| Item | Date     | Description                      |
|------|----------|----------------------------------|
| 1    | 01/14/14 | Amendment 1 - Project Alternates |

1 Overall Floor Plan - First Floor  
1/16" = 1'-0"

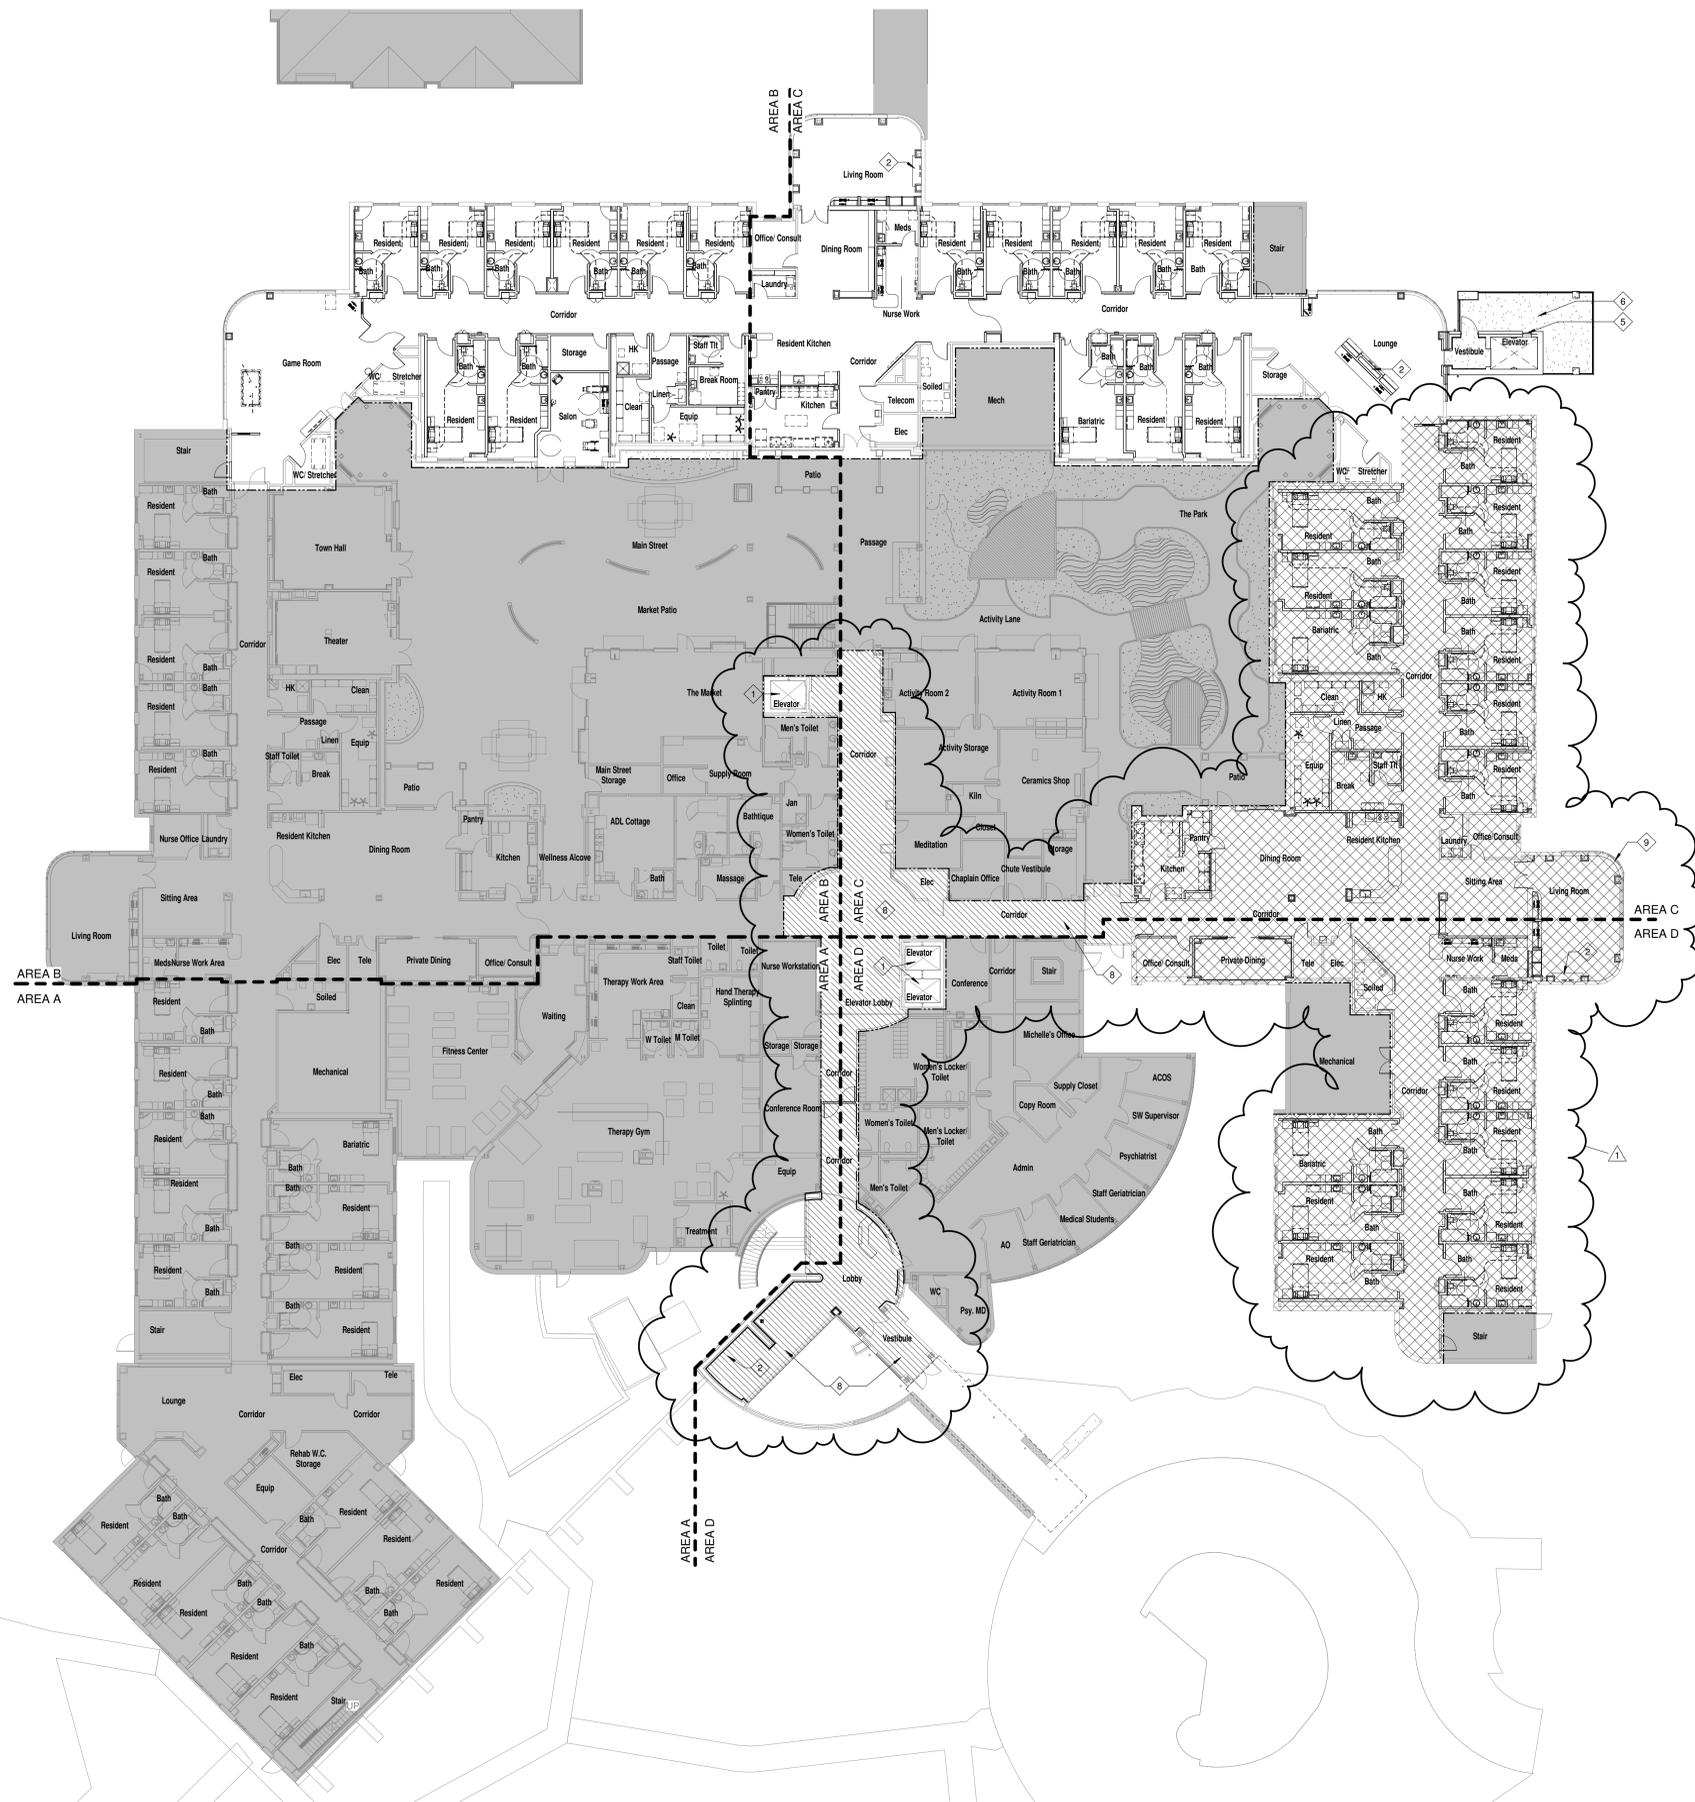
1. SEE A321 FOR ELEVATOR FINISHES. ALT. SEE SPECIFICATION SECTION 01 00 00.
2. FIREPLACE. ALTERNATE. SEE SPECIFICATION SECTION 01 00 00.
3. FORMAL DINING ROOM. ALT. SEE SPECIFICATION SECTION 01 00 00.
4. ELEVATOR VESTIBULE CEILING AND ROOF DESIGN. ALT. SEE SPECIFICATION SECTION 01 00 00.
5. GLASS AT ELEVATOR TOWER AND IN ELEVATOR CAB. ALT. SEE SPECIFICATION SECTION 01 00 00.
6. PORCH AT ELEVATOR TOWER. ALT. SEE SPECIFICATION SECTION 01 00 00.
7. NEW PERIMETER WALKWAY AT EXISTING ROOF WITH ELEVATED PAVER SYSTEM. SEE SPEC 01 00 00.
8. A WING ALT. (DIAGONAL HATCHED AREA). SEE SPEC 01 00 00.
9. D WING ALT. (CROSS-HATCHED AREA). SEE SPEC 01 00 00.
